South Texas Project
Units 1 and 2
Docket Nos. STN 50-498, STN 50-499
Response to Request for Additional Information for the
South Texas Project License Renewal Application (TAC Nos. ME4938 and ME5122)

**SOUTH TEXAS PROJECT
LICENSE RENEWAL APPLICATION
REQUESTS FOR ADDITIONAL INFORMATION**

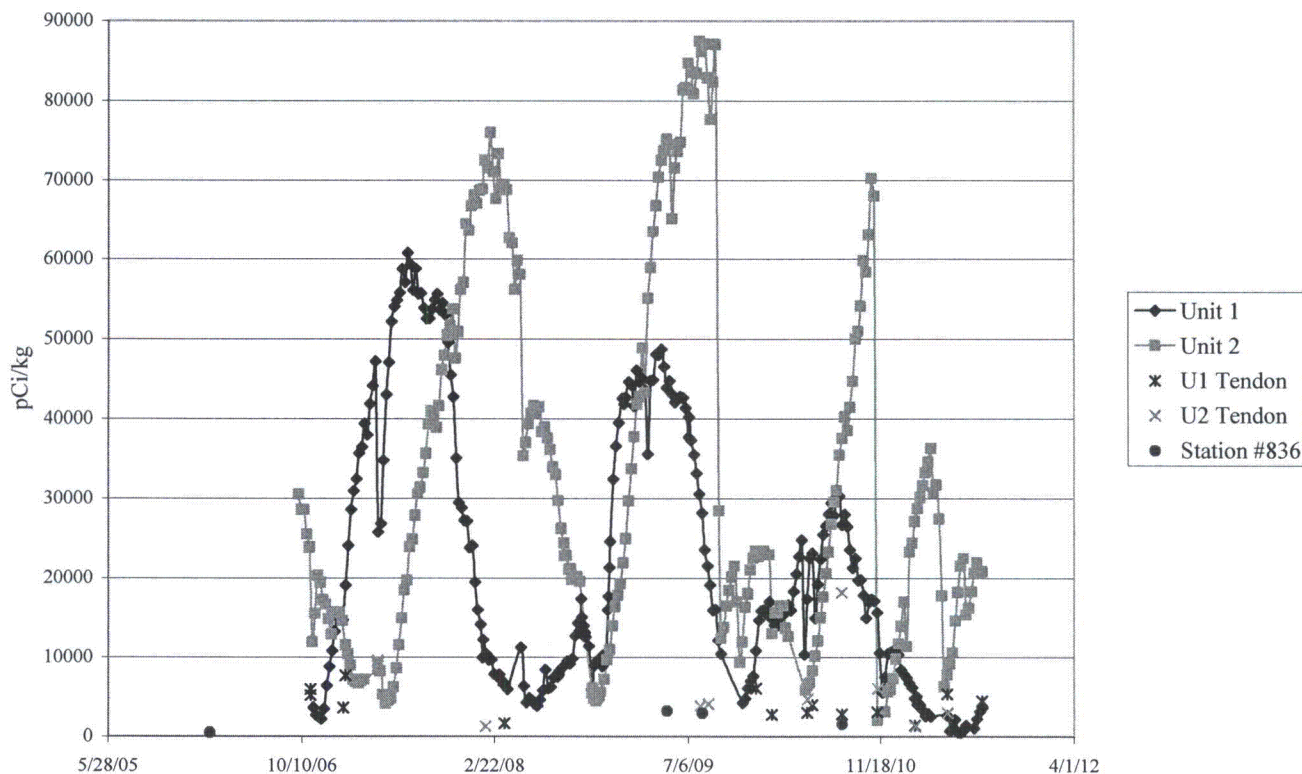
For clarification purposes, the staff requests the proposal or planning documentation or both, including documentation of the existing steam condensate quantity and quality, related to the proposed engineering change to the "Auxiliary Steam and Condensate Storage and Transfer Piping" to eliminate the discharge of tritium directly to the ground surface. Further, please clarify and provide supporting documentation on the interception of these releases by (a) the sump(s) within the tendon gallery of each reactor containment building and (b) the sump water release point(s).

A project plan request was submitted to the Plant Investment Plan to reroute steam drain lines to a controlled sump inside the Turbine Generator Building to collect low-level tritium radioactivity. The request is STP Project Approval Request (PAR) #101340 and is available on the STP License Renewal Application Online Reference Portal. PAR #101340 is located on the portal under "STP NRC Document Requests" folder as Document Request WR-18: PAR #101340.

The proposed change addresses steam traps from piping branching off the Main Steam System to the Auxiliary Steam Piping. The steam traps discharge directly to the ground adjacent to both turbine buildings. It is believed that the condensate from the steam traps migrates from the ground surface to the lower shallow aquifer.

The project plan is awaiting Project Review Team review, categorization and assignment of priority. The amount of tritium released to the environment continues to be monitored, measured and reported. As discussed below, the amount of tritium released from these steam traps is subjected to considerable dilution and delay so that there is minimal impact on the environment.
